Crystal River Nuclear Plant
Docket No. 50-302
Operating License No. DPR-72

August 11, 2011
3F0811-02

Subject: Crystal River Unit 3 – Response to Request for Additional Information to Support NRC Balance of Plant Branch Acceptance Review of the CR-3 Extended Power Uprate LAR (TAC No. ME6527)

**RESPONSE TO REQUEST FOR ADDITIONAL INFORMATION
TO SUPPORT NRC BALANCE OF PLANT BRANCH
ACCEPTANCE REVIEW OF THE CR-3 EPU LAR**

Simplified Diagram of EFP-3 Recirculation Valve

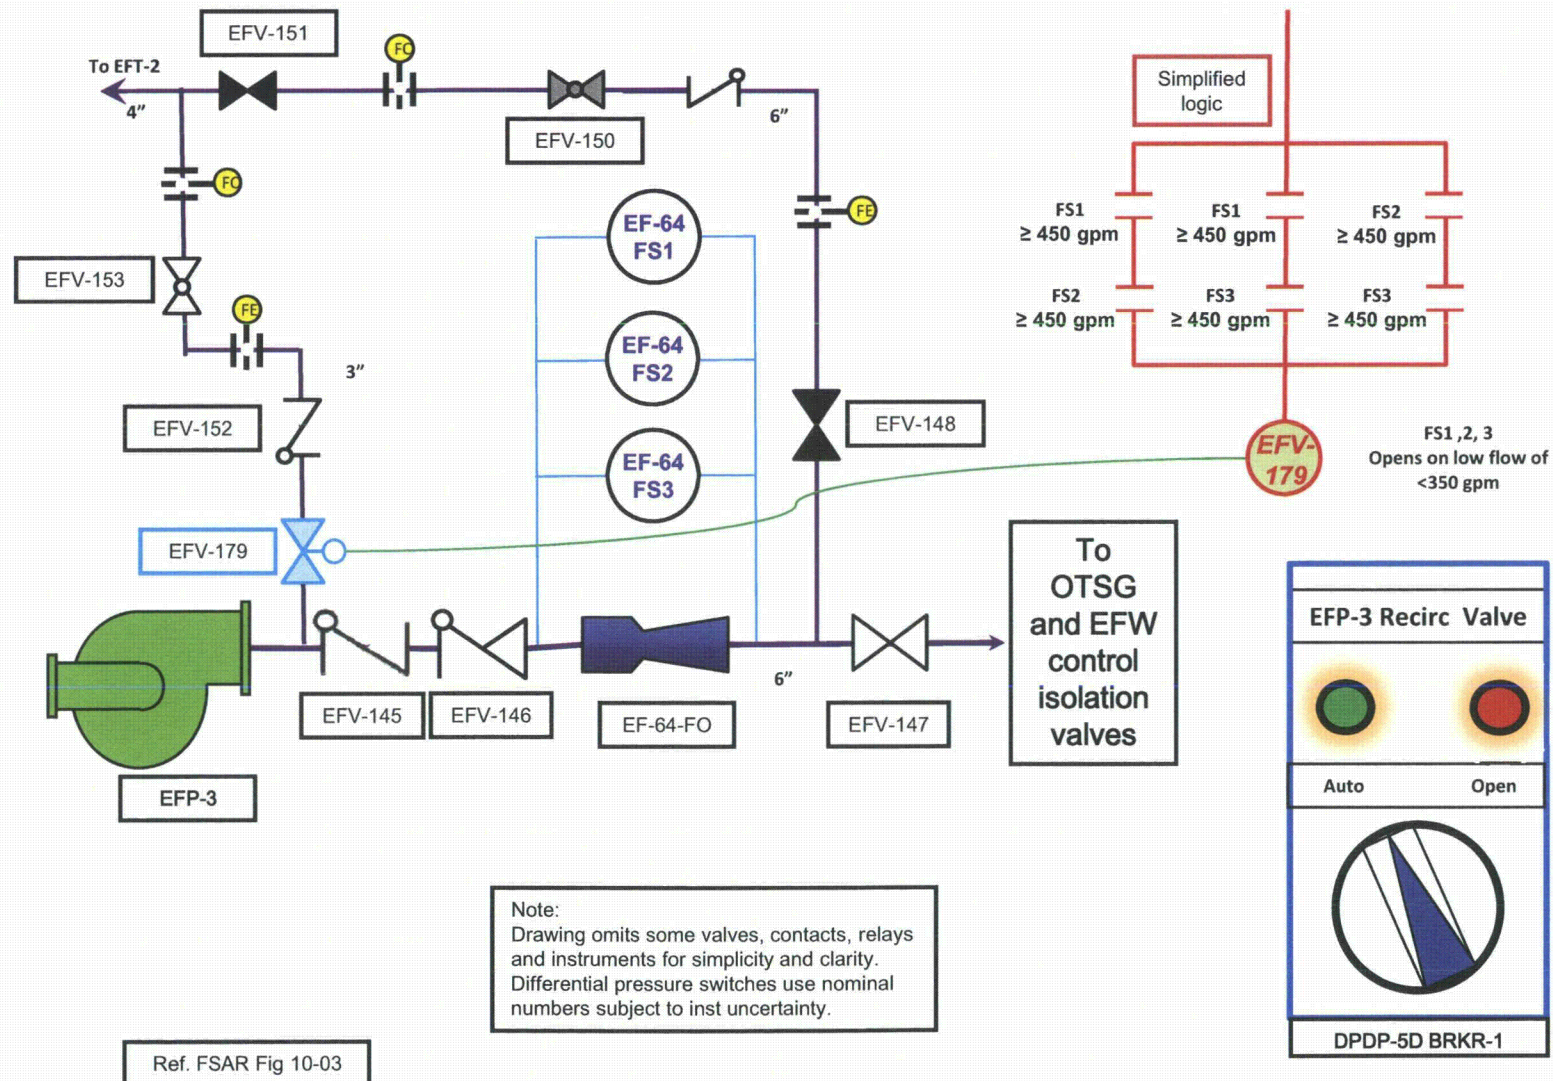
3. **In several locations in the LAR, the licensee briefly describes a modification to the minimum flow recirculation control for the emergency feedwater pumps. Improper operation of the modification could cause failure of the pump, and the modification could be configured such that it introduces cross-train dependencies. The licensee must provide details of the modification necessary to establish that the modification would not adversely affect the independence of the emergency feedwater trains, such as a failure modes and effects analysis, and that the modification would not substantially reduce the reliability of the individual pumps (TMI Action Plan Item II.E.1.1), consistent with the guidelines of SRP Section 10.4.9.**

The EFW System consists of two independent, 100% capacity, safety-related trains. The A EFW train consists of a diesel driven pump (EFP-3), flow limiting cavitating venturi, and flow control valves to each OTSG. The B EFW train consists of a turbine driven pump (EFP-2), flow limiting cavitating venturi, and flow control valves to each OTSG. Each of the new recirculation valves will be controlled by three safety-related differential pressure switches that sense flow across the associated cavitating venturi. A “2 out of 3 logic” will be required to open or close the associated safety-related EFW pump recirculation valve. EFW pump recirculation valve simplified piping diagrams are provided in Enclosure 3 showing the new valves in the EFW pump recirculation line and the sensing differential pressure instrumentation. The differential pressure switches, logic, control and motive power for each recirculation valve will be powered from the same safety-related electrical train as the associated EFW train.

A control switch will be added to the control room for each of the new EFW pump recirculation valves. Each switch will have “open” position to allow overriding the automatic operation forcing the valve to the open position. Control room alarms will also provide indication of the new valves “out of position” when the control switches are overriding the automatic function. As stated in the proposed CR-3 Improved Technical Specifications (ITS) Bases B 3.7.5, “Emergency Feedwater System” (Reference 1, Attachment 4), the EFW pump low flow instrumentation is required to be capable of closing the associated recirculation line isolation valve in sufficient time to ensure that EFW discharge flow to the OTSGs as assumed during transients and accidents is met. Thus, if an EFW pump recirculation valve control switch is placed in the open position, the associated EFW train would be rendered inoperable and ITS 3.7.5 Actions would apply.

The new EFW pump recirculation valves and control logic are designed to ensure pump protection for long term reliability. Although the safety function position of the valve is closed to ensure the minimum 660 gpm for the LOFW event, the new valves are spring to open and will fail open on a loss of power. In addition the control logic was designed requiring 2 of 3 flow signals to close the valve and no ability to manually close the recirculation is provided in the main control room. This design was chosen to minimize the probability of operating the EFW pump with no flow resulting in possible pump damage. Designing the valves to fail in the open position is considered acceptable based on:
